**ARCHITECTURAL REVIEW BOARD
MUNICIPAL PLANNING COMMISSION
-AGENDA-
Thursday, May 28, 2026 at 7:00 P.M.**

1. **Rezoning** – PUD Preliminary Plan – **445 E. Granville Rd.** (Elford Development/Boundless) **PUD 01-2026**

SUBJECT: Staff Memo for the Meeting of May 28, 2026

1. **Rezoning** – PUD Preliminary Plan – **445 E. Granville Rd.** (Elford Development/Boundless)
PUD 01-2026

1 Tree Preservation Plan
SCALE: 1" = 80'-0"

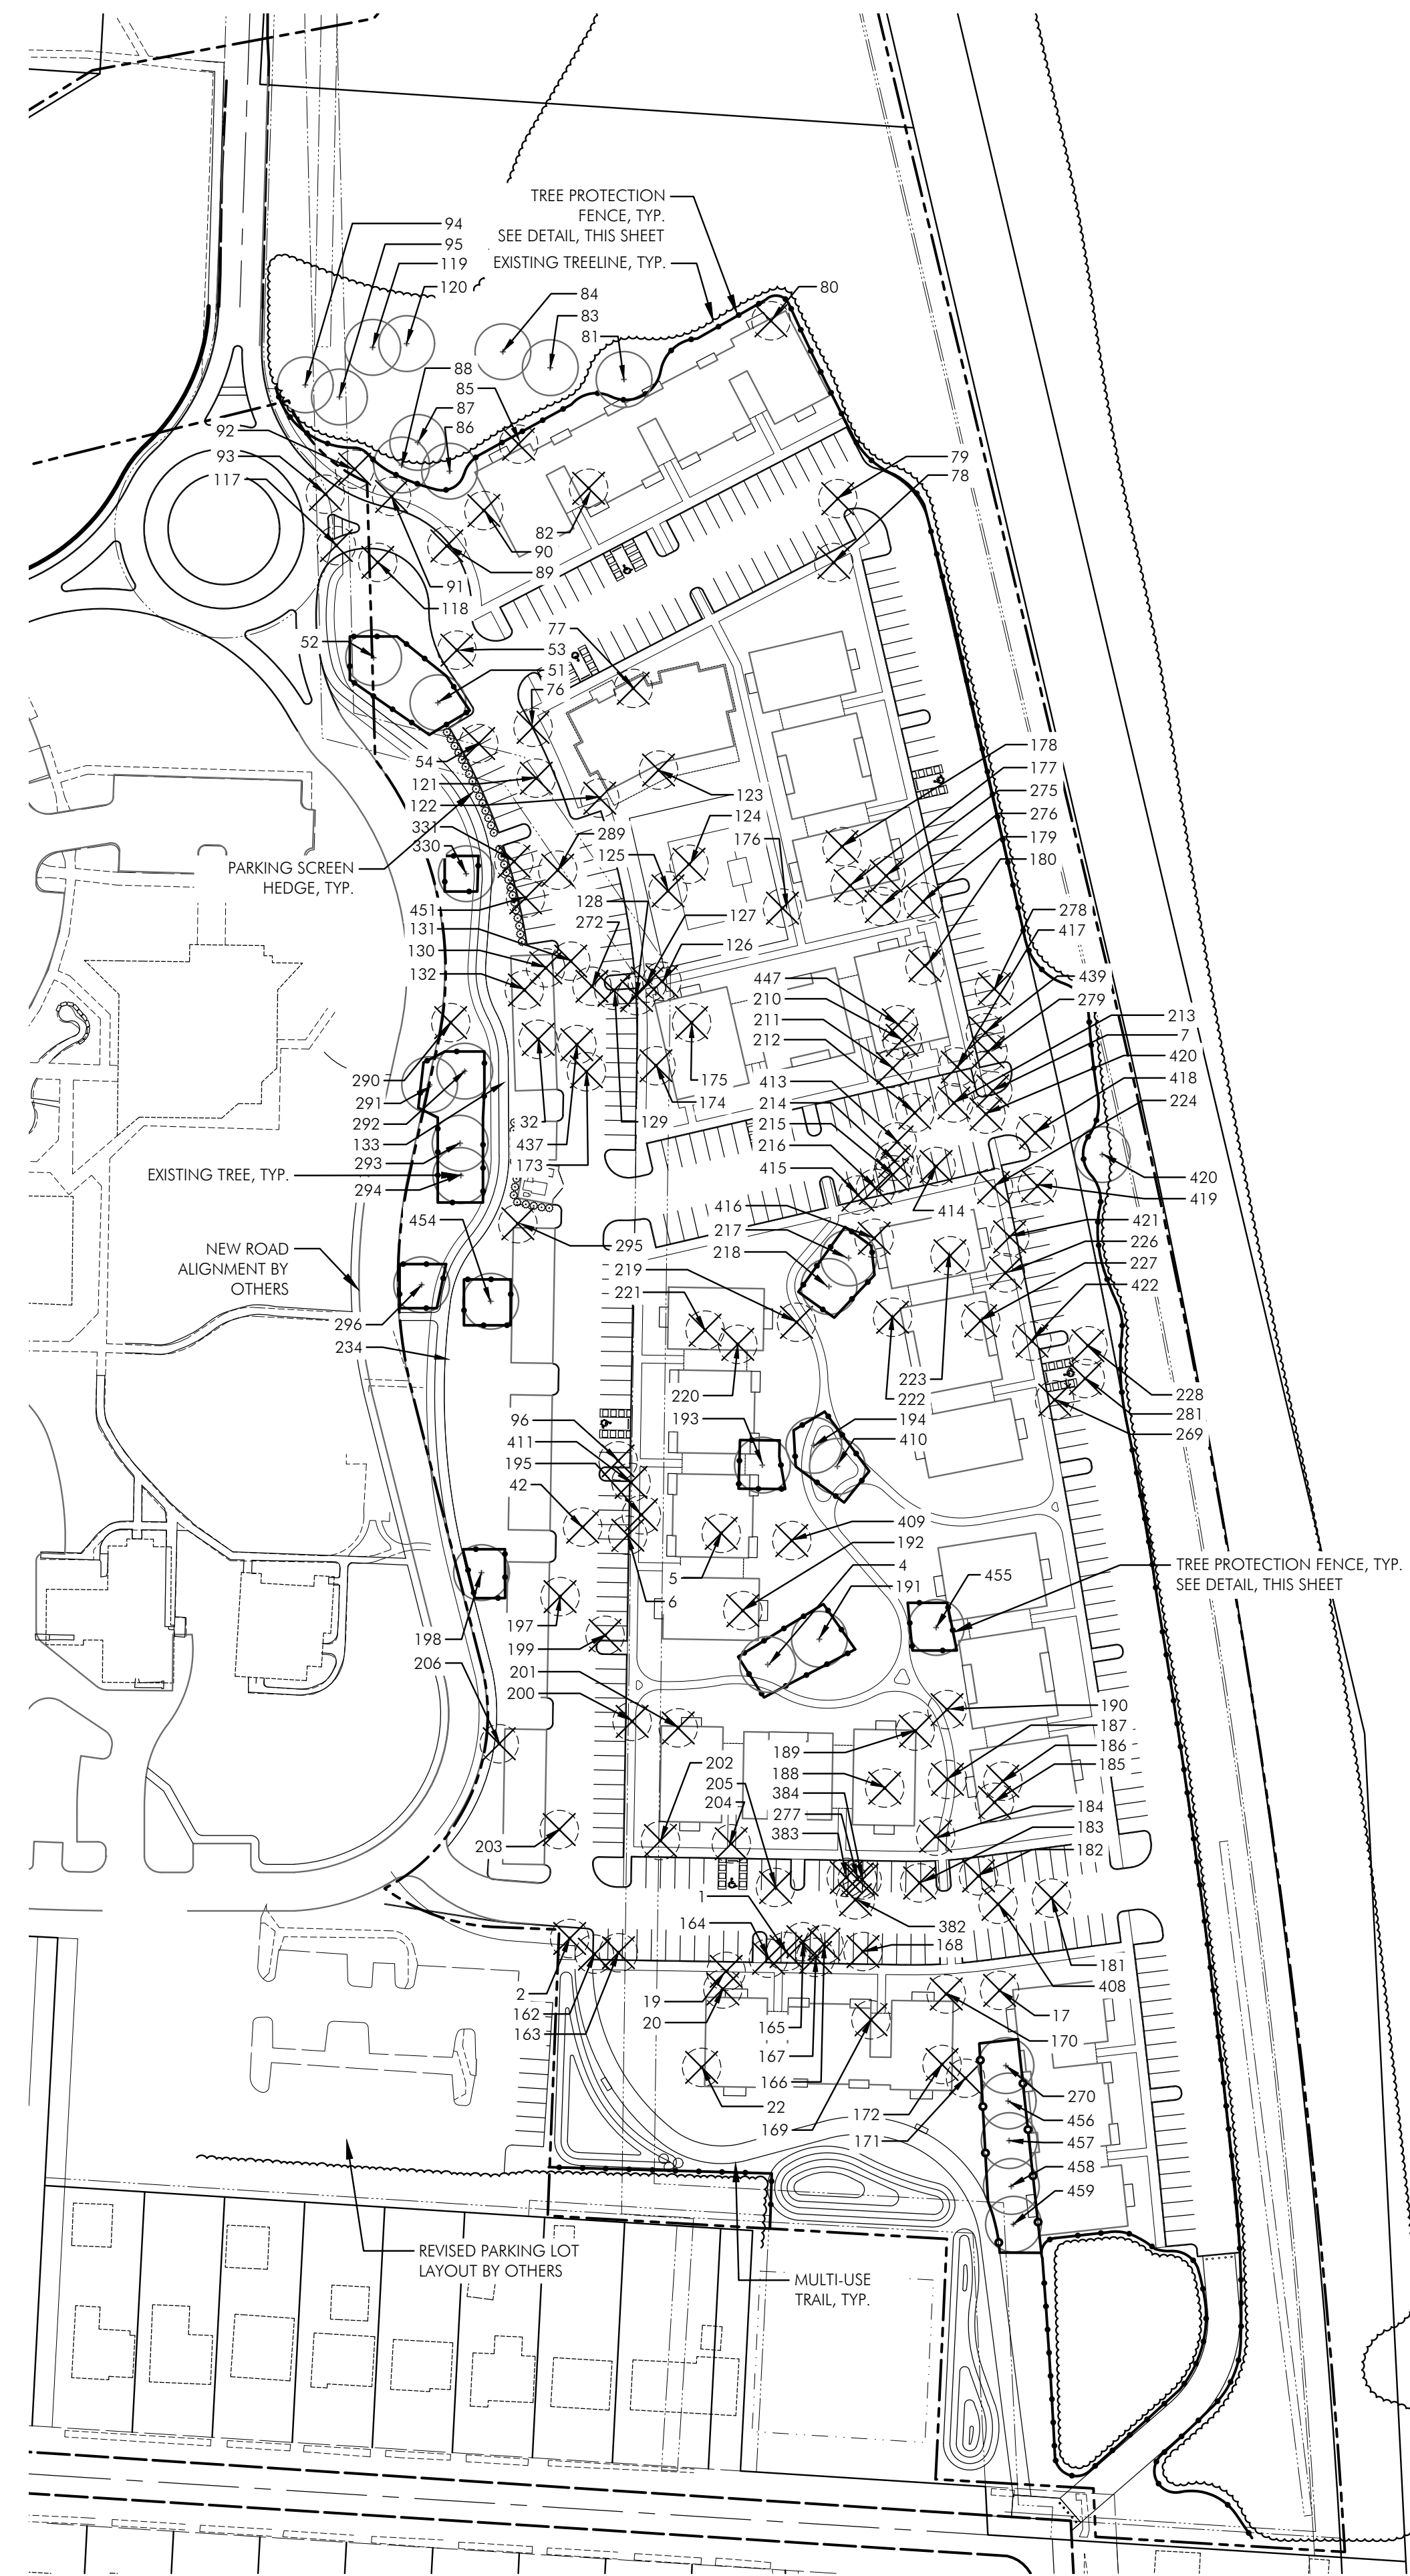
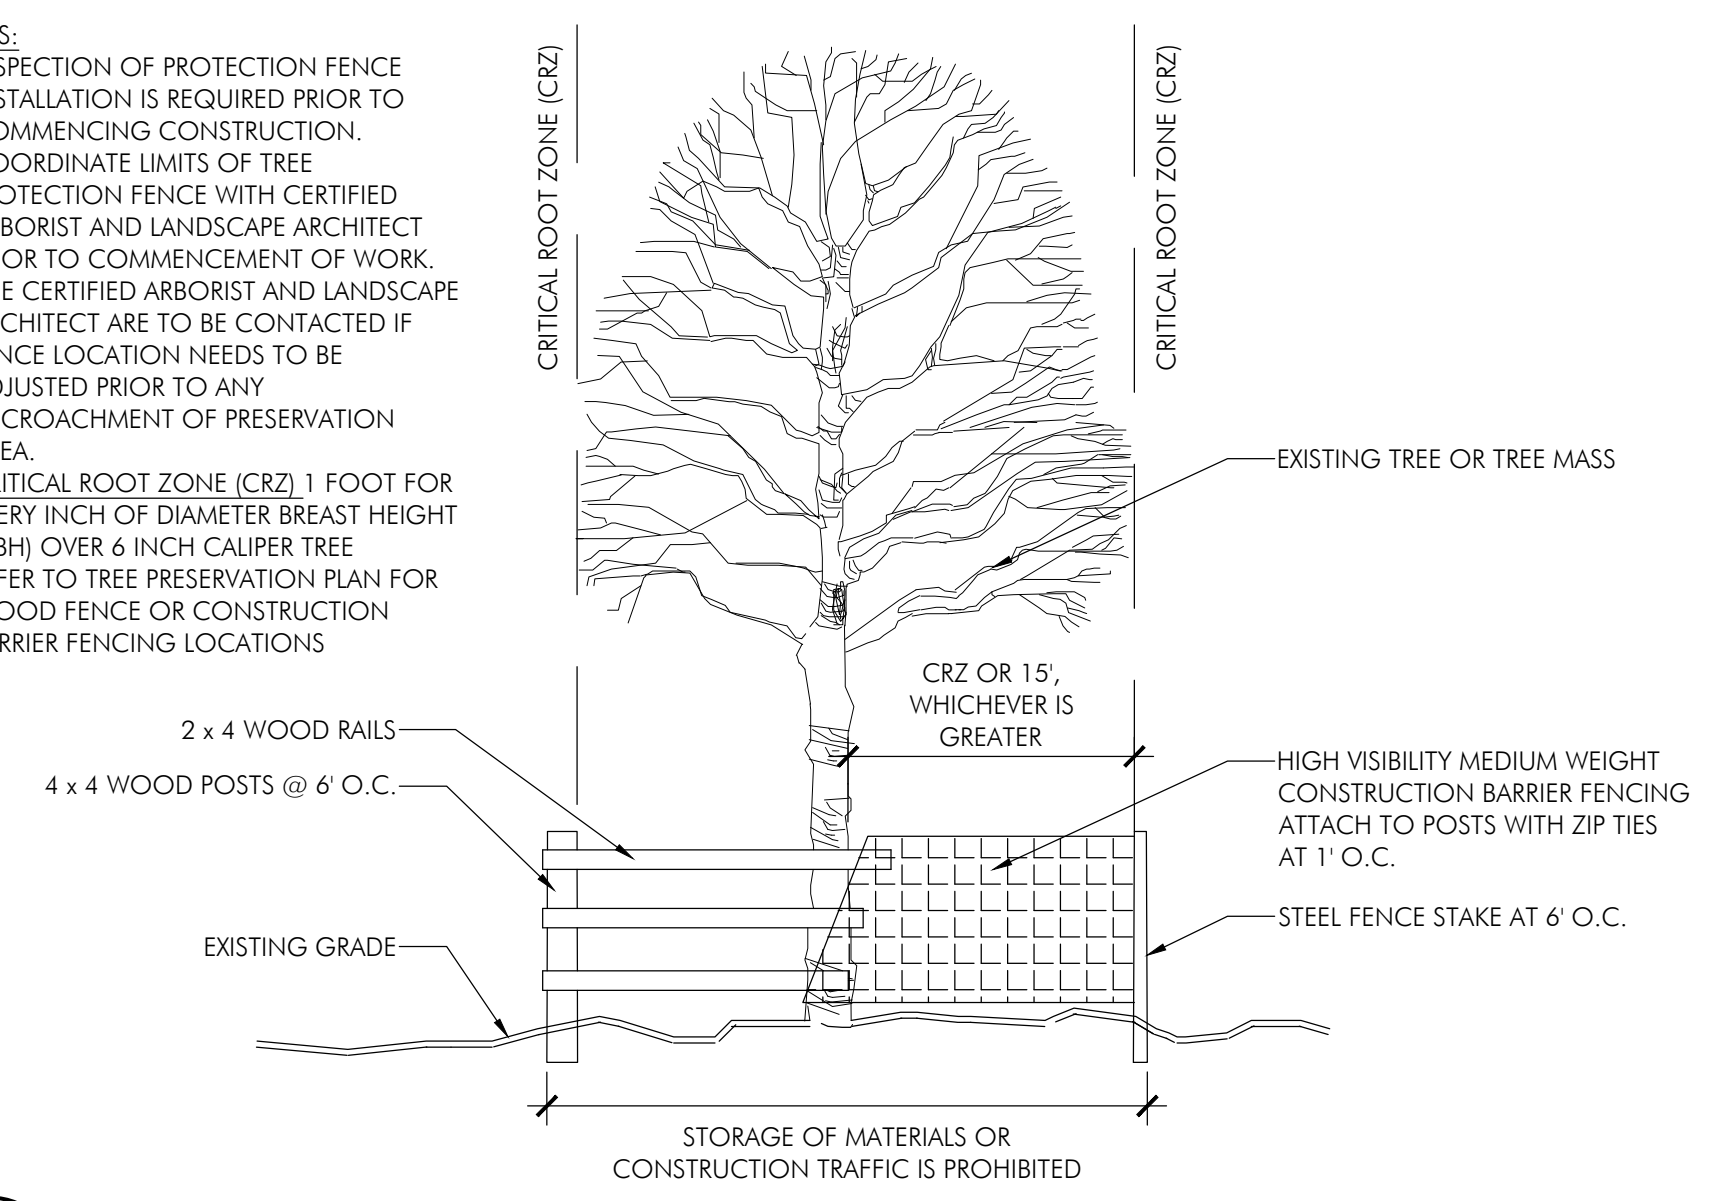
- i. Natural Features
 - 1) Tree Preservation/Replacement
 - All trees 6” and larger have been identified and the condition evaluated in consultation with a City Arborist. Alignment was slightly modified to save certain trees.

- Any trees removed or damaged in conflict with the Tree Preservation Plan will be replaced
 - **Tree removal - 135 trees:**
 - 88 trees in poor, very poor and dead condition

- **47 trees in fair or good condition**
 - **1172 caliper inches to be removed in fair to good condition**
 - **Tree Replacement Plan - 275 trees planned**

TREE REPLACEMENT PLAN

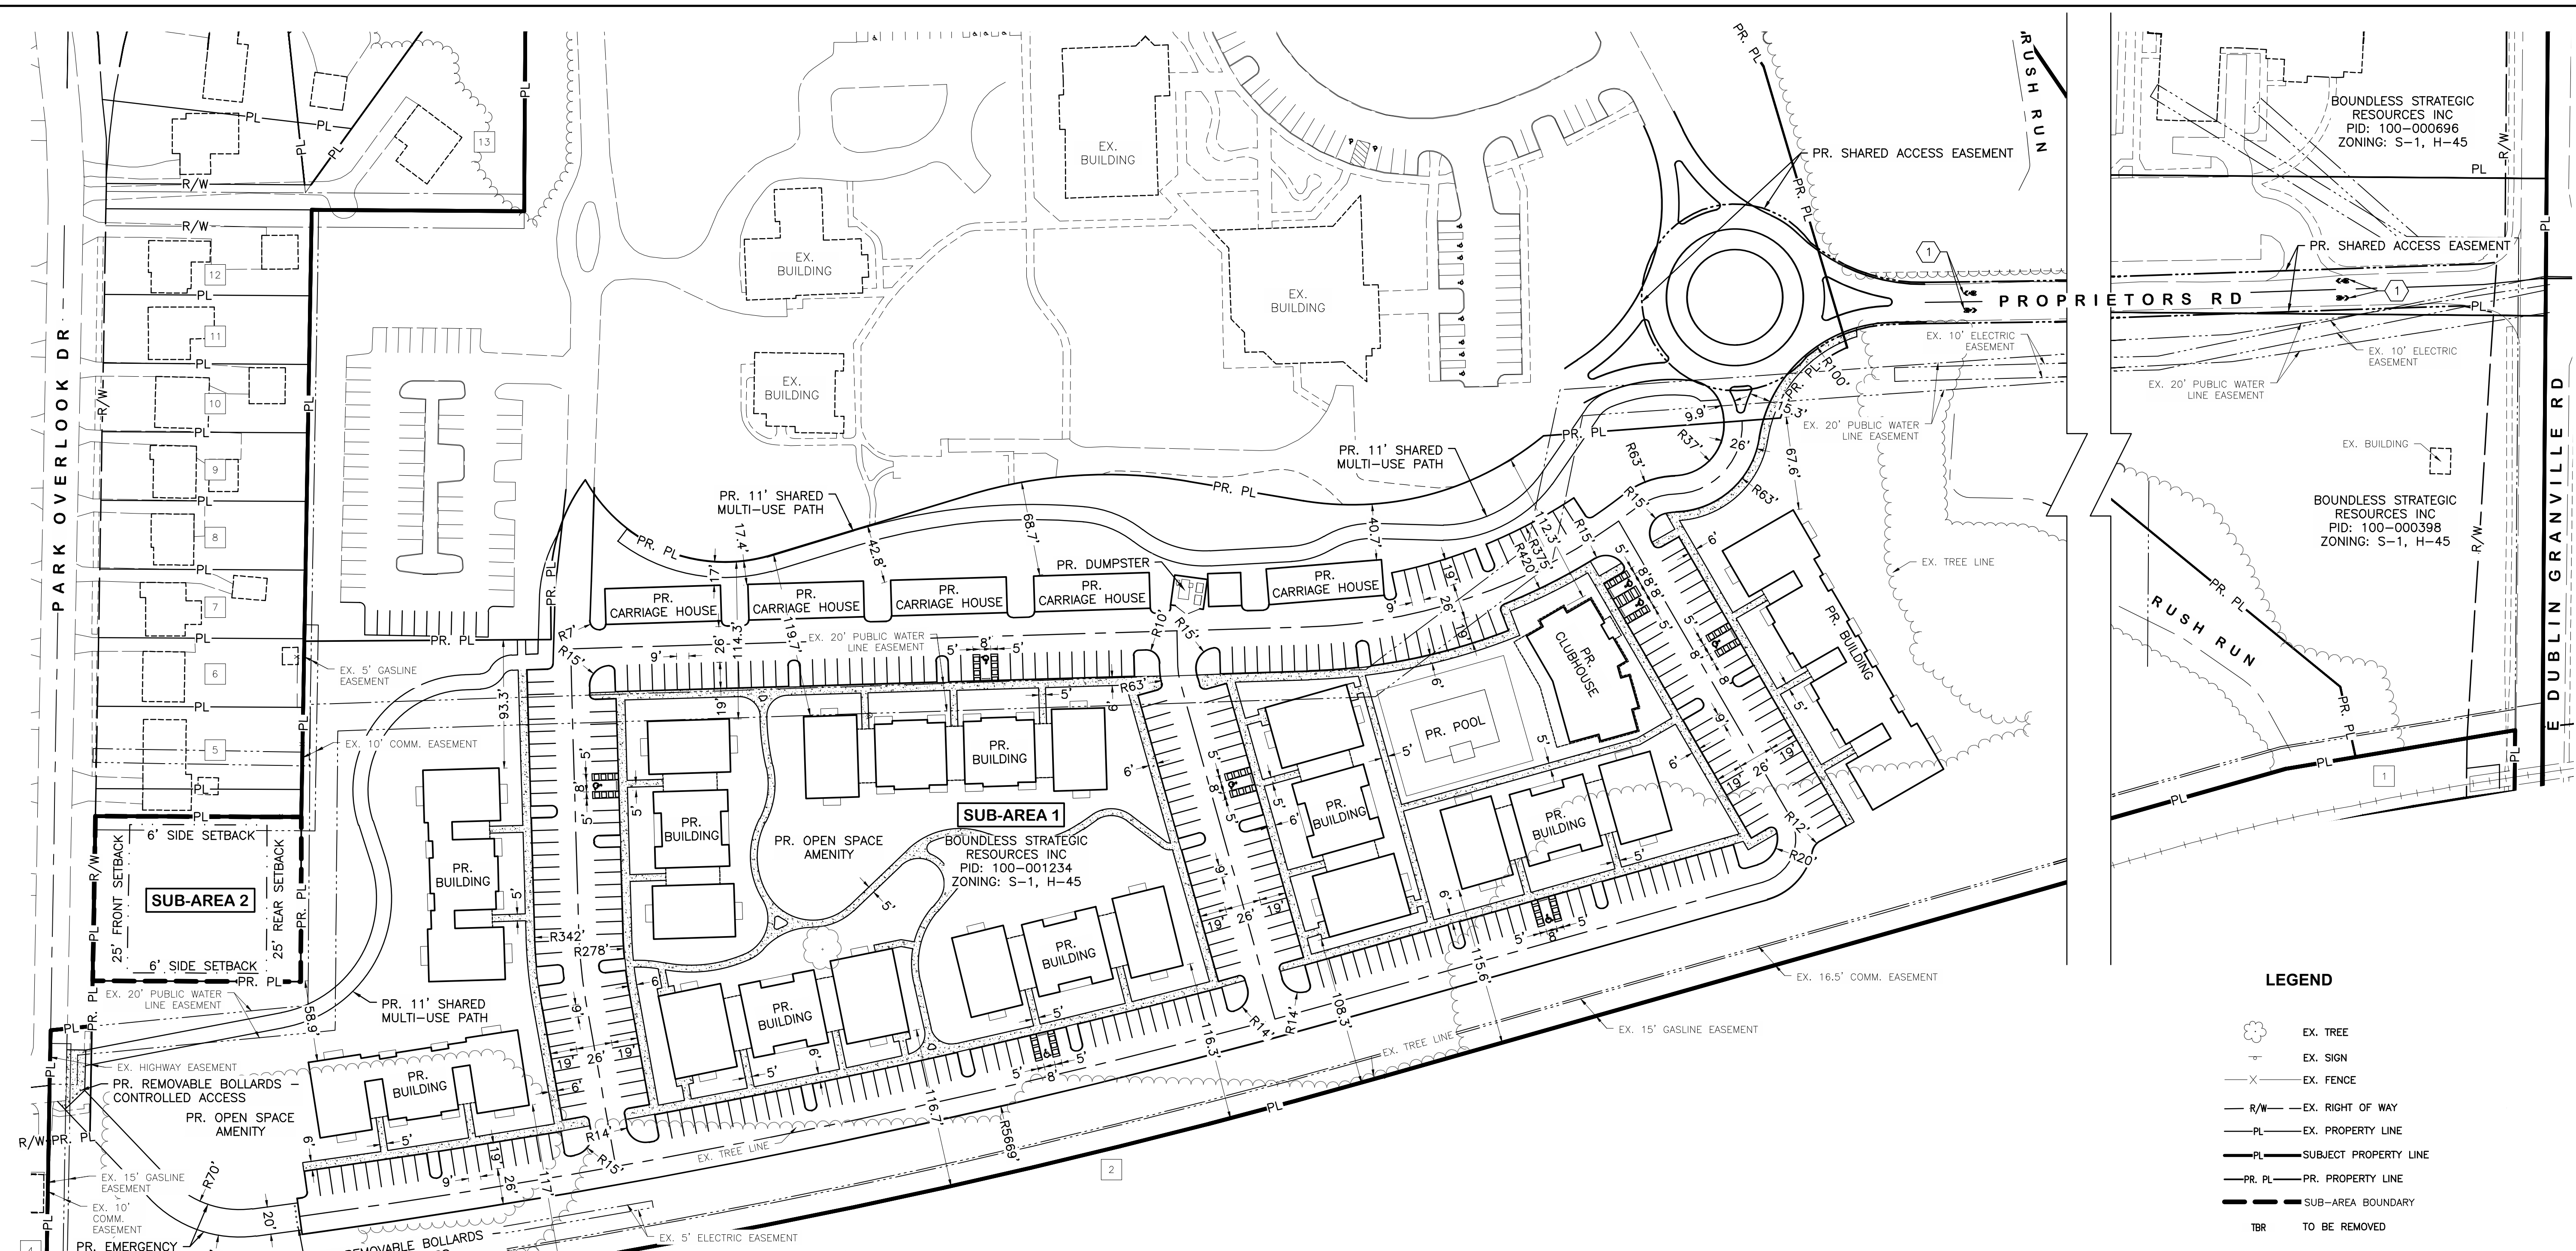
- **668 caliper inches to be added**
 - 54 trees to meet parking lot requirement (325 parking spaces/6)
 - **91 added for screening from existing residential**
